Case Name/ Number: RCU2023-00029/ JEA Event Center
CUP

Development Review Team Comments

Project Name: JEA Event Center

Commenting Division: Plan Coordination 2nd Review

Site Plan
41901 E 88th Ave
Bennett, CO 80102

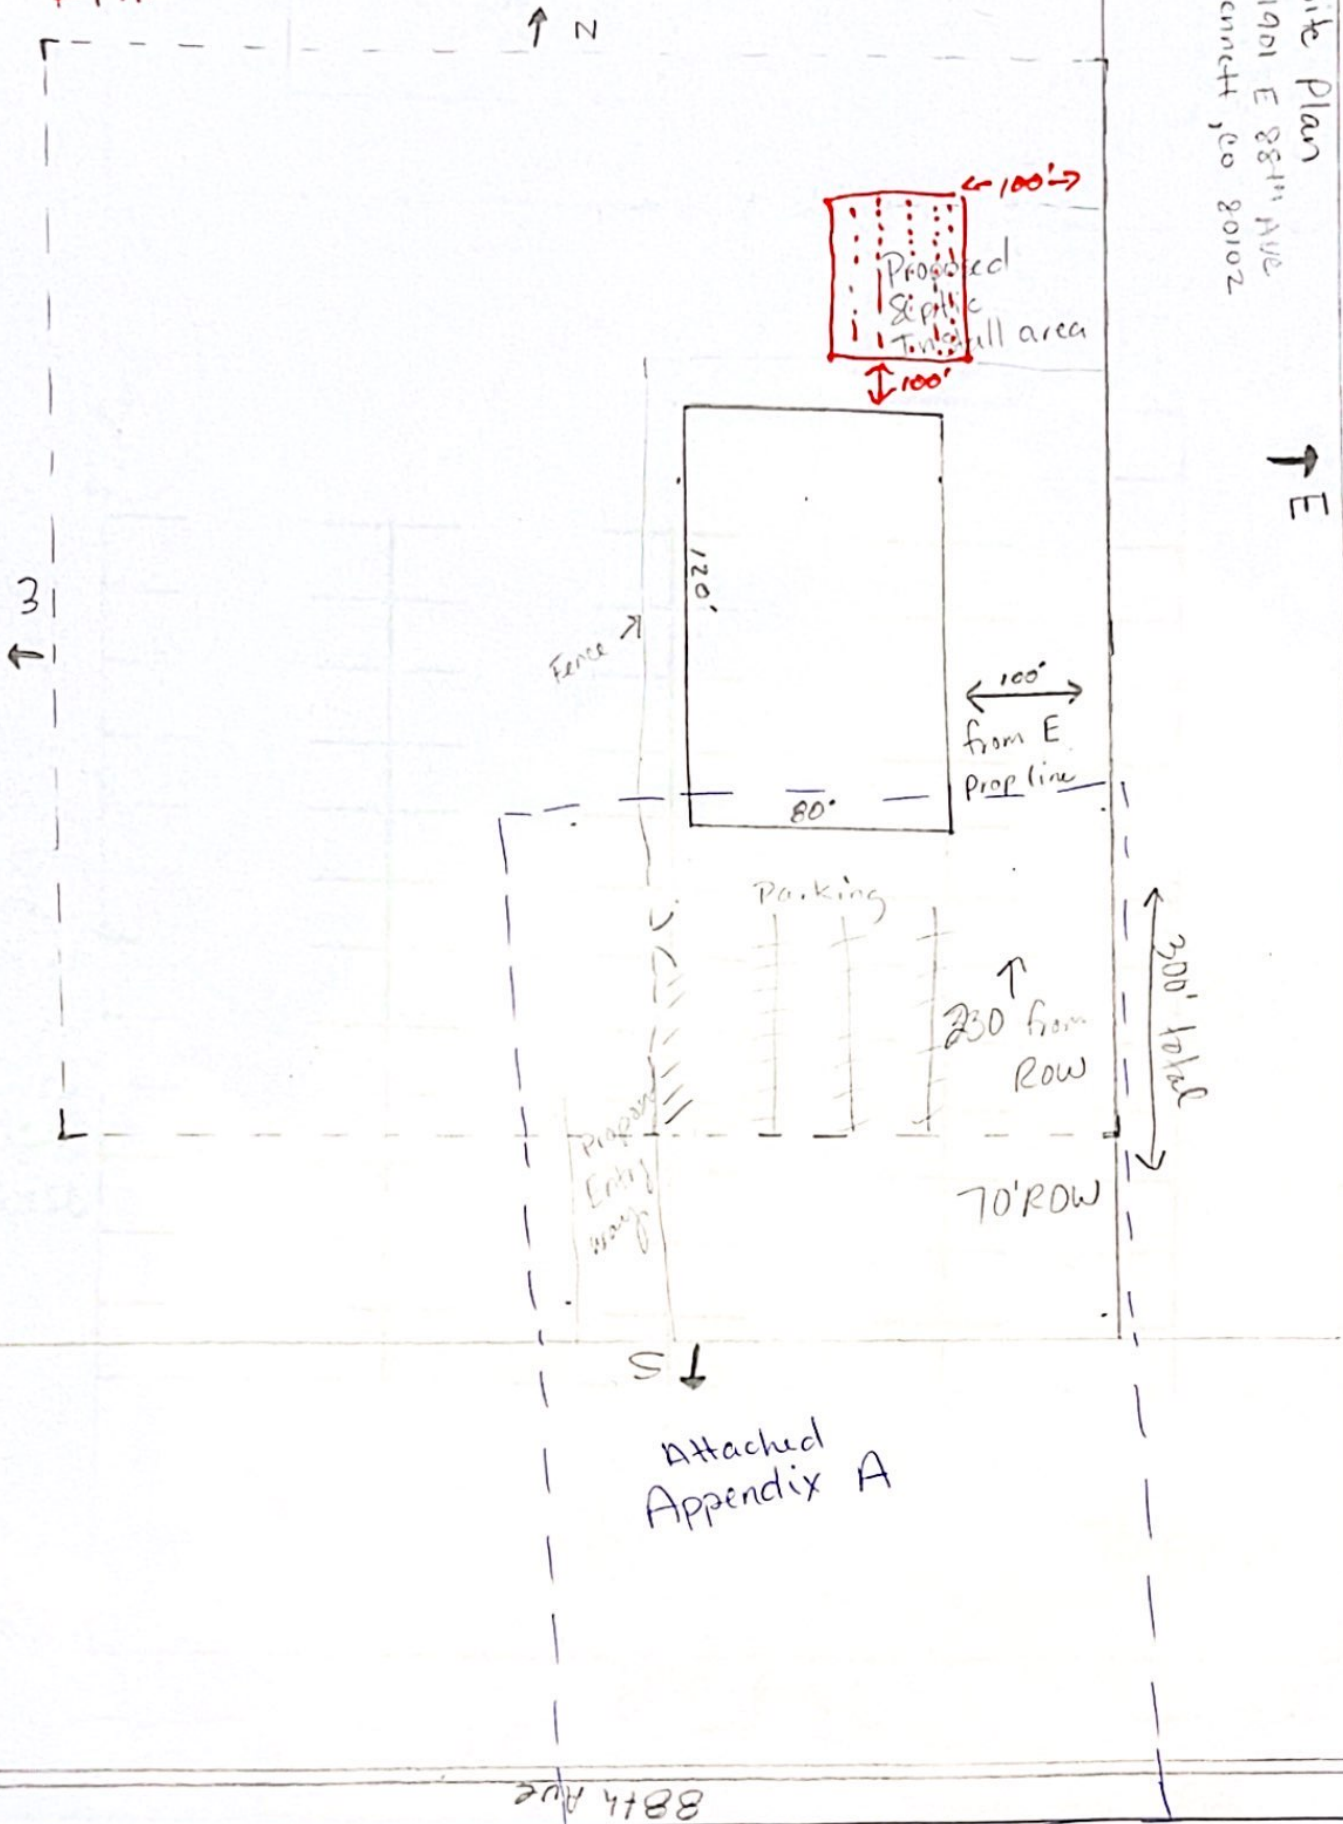
PLN01: Please submit a site plan that is drawn more to scale.

PLN02: Provide a parking plan that shows the appropriate amount of spaces, layout, and surface the vehicles will be parked on. *Appendix A*

Attached Appendix A

1 space for
4 people =
100 spaces

Surface
will be
Road base

Currently
Existing
Exhibit A

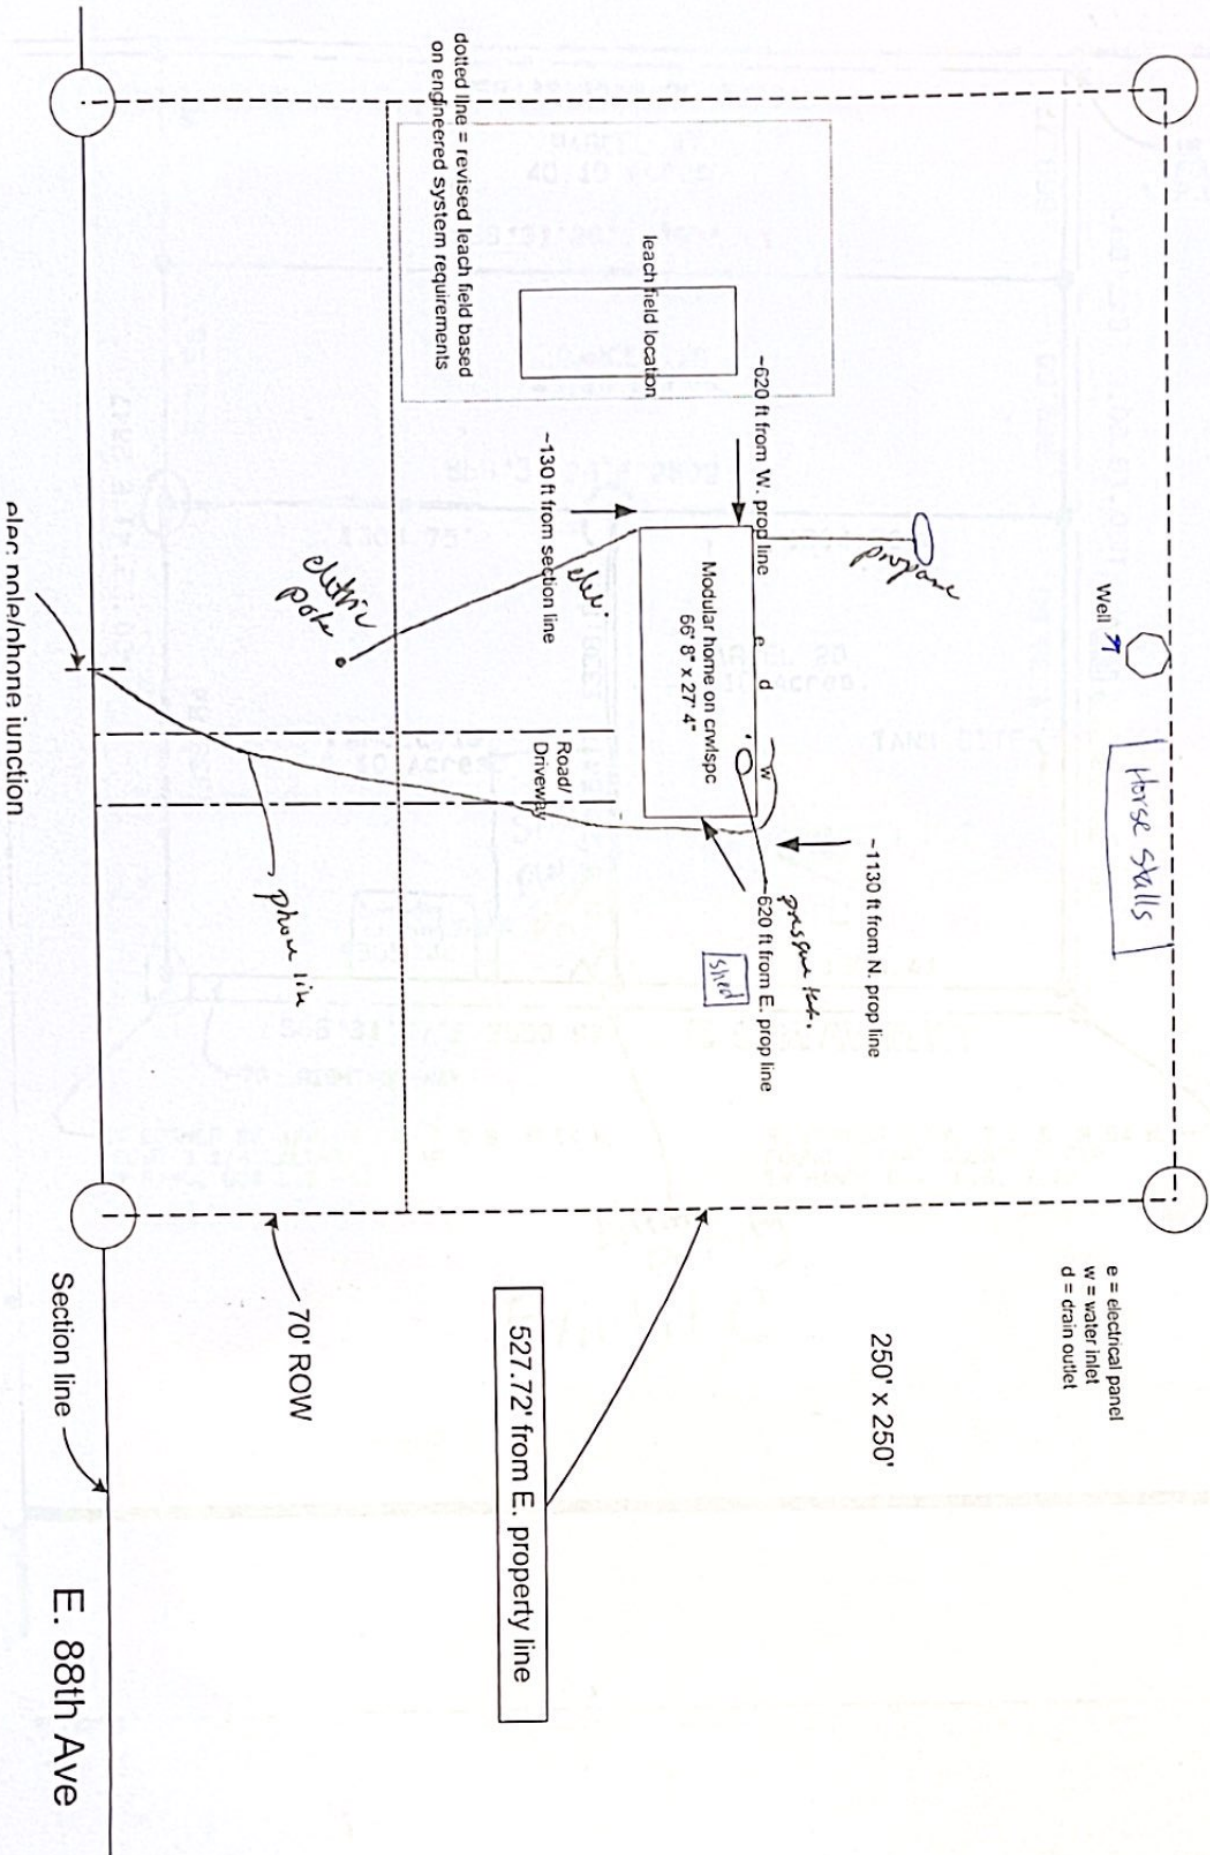
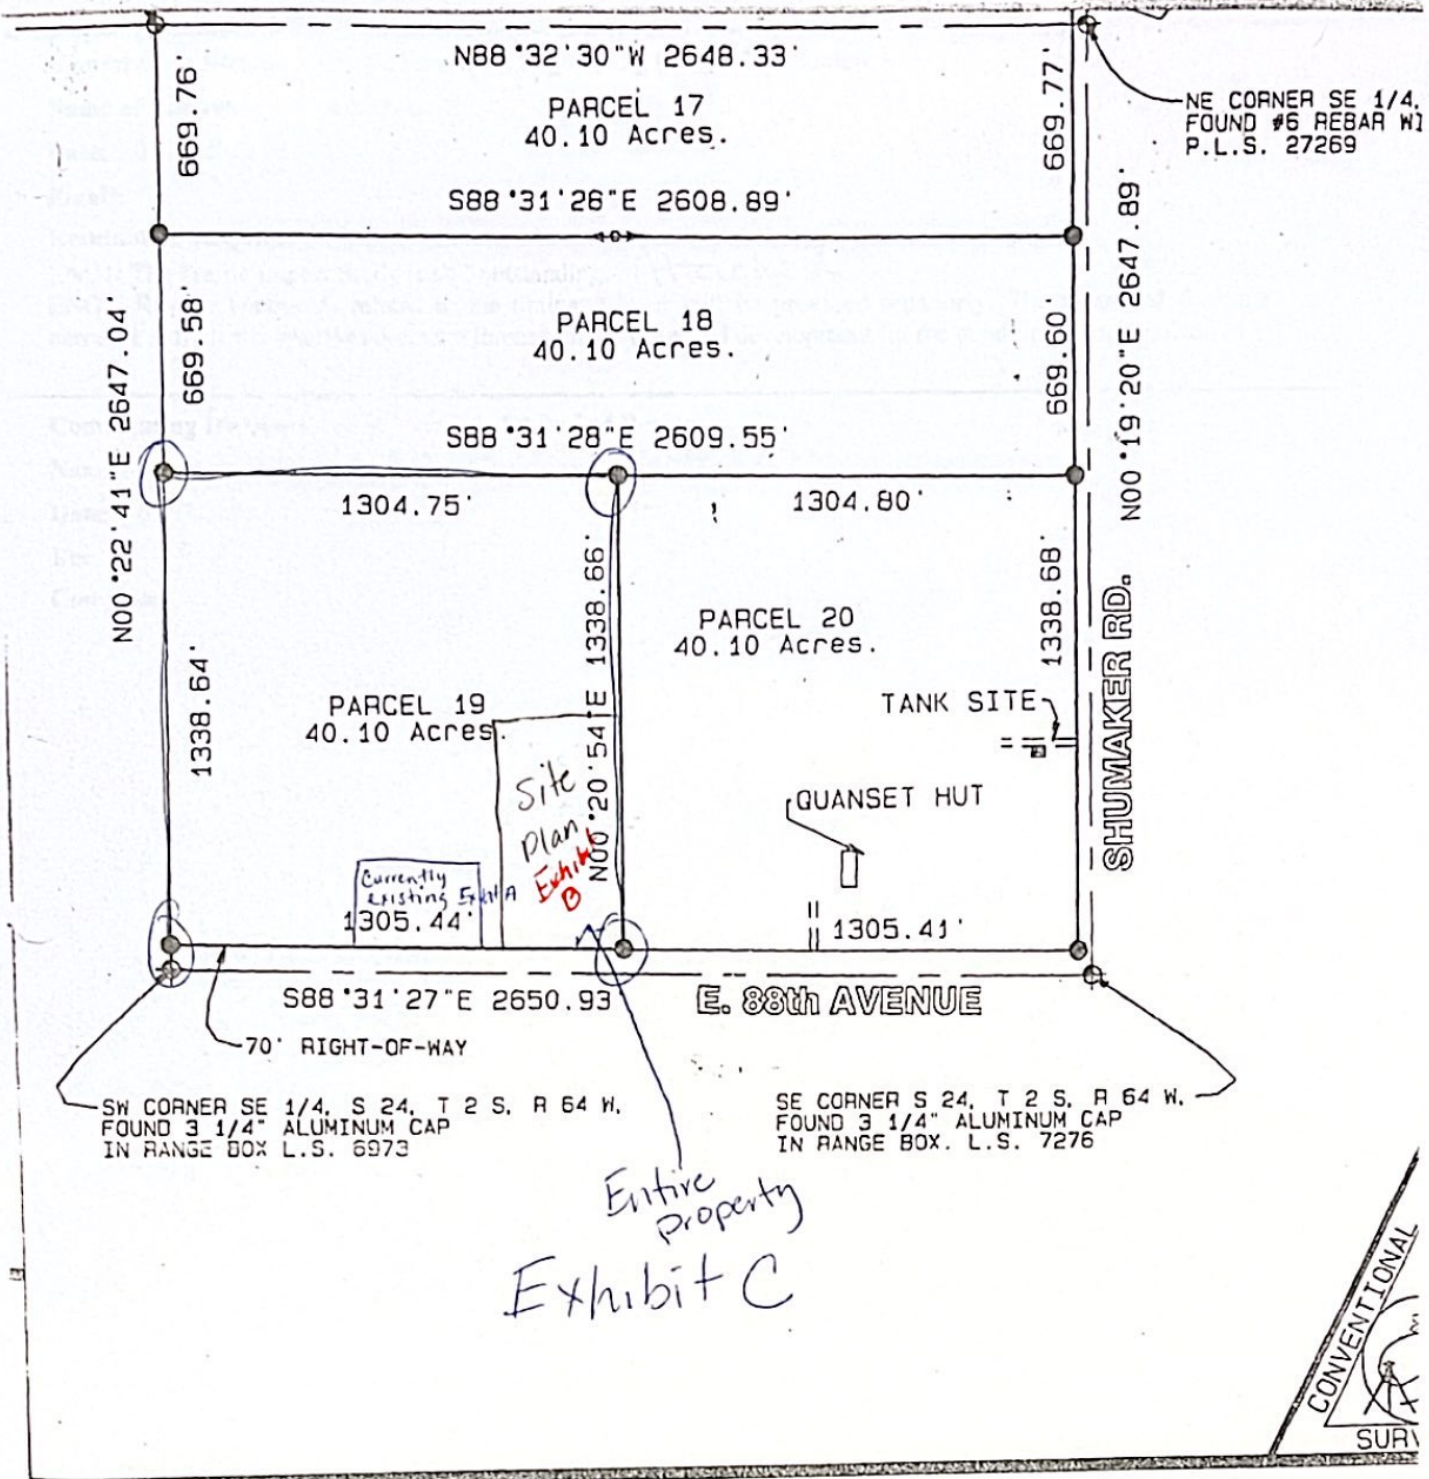
ENV4. Where is the existing water well located on the site plan? Please add this feature.

ENV4: Water well Was sent on previous Currently Existing site plan Exhibit A which will be reattached to this. Also attached Entire Property line Exhibit C for reference of where things are and going to be placed.
